# **An Bord Pleanála Oral Hearing**

### **Dublin to Cork Railway Line Level Crossings**

#### **Brief of Evidence**

#### **Overview of Railway Order & Railway Works**

Figure 2.3: XC187 Fantstown Proposed Solution

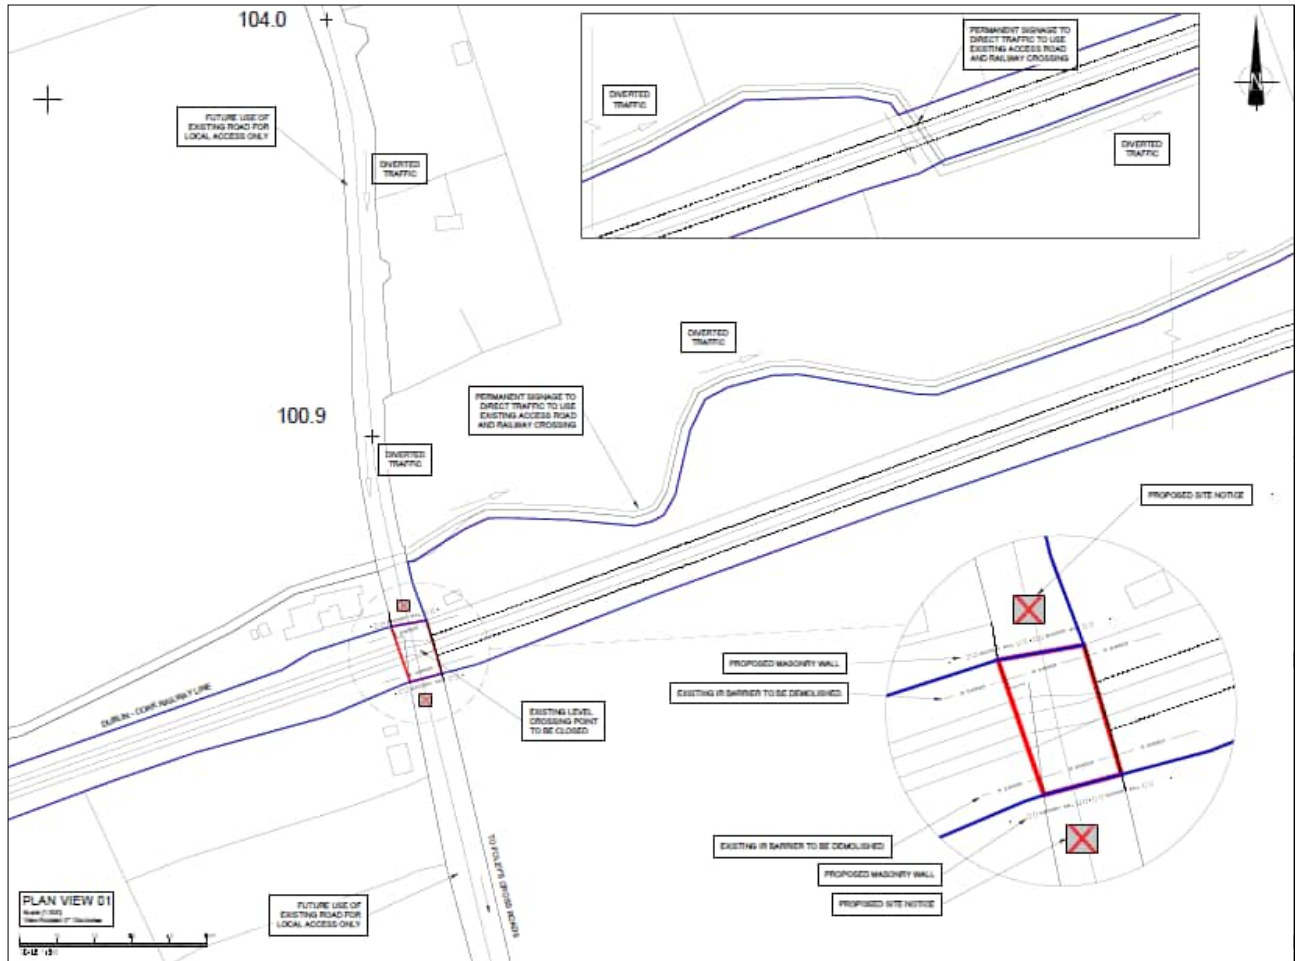
- 5 I am asking An Bord Pleanála to drive the alternative routes when they visit Fantstown crossing XC187. The alternative road by Gibbonstown is narrow and has dangerous bends and is not suitable to an increased traffic burden. The crossing at Ballinscaula is already accepted as dangerous and no plans have been shown for upgrading this. In particular children and the elderly will not be safe using these roads. They will also not be safe on the main Tipperary to Kilmallock road as cars travel very fast on this stretch of the journey.

Figure 2.5: XC201 Thomastown Proposed Route Alignment

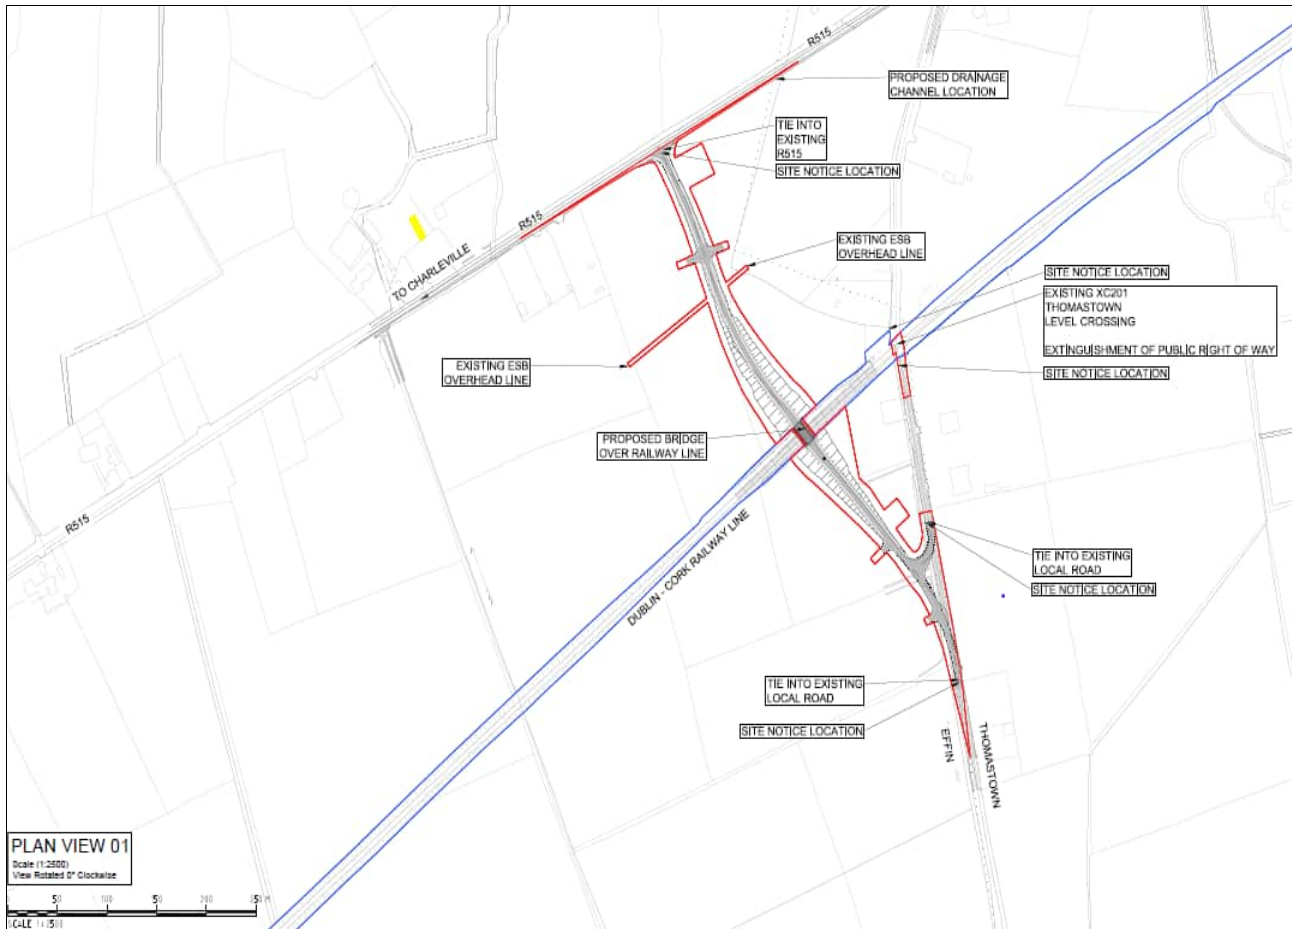
- 121 There are safety concerns with the width of the road which is not wide enough to pass safely through. The new junction planned for the Charleville -Kilmallock road (R515) needs to be reviewed as it will cause stacking of vehicles when turning off the R515 to the new road.
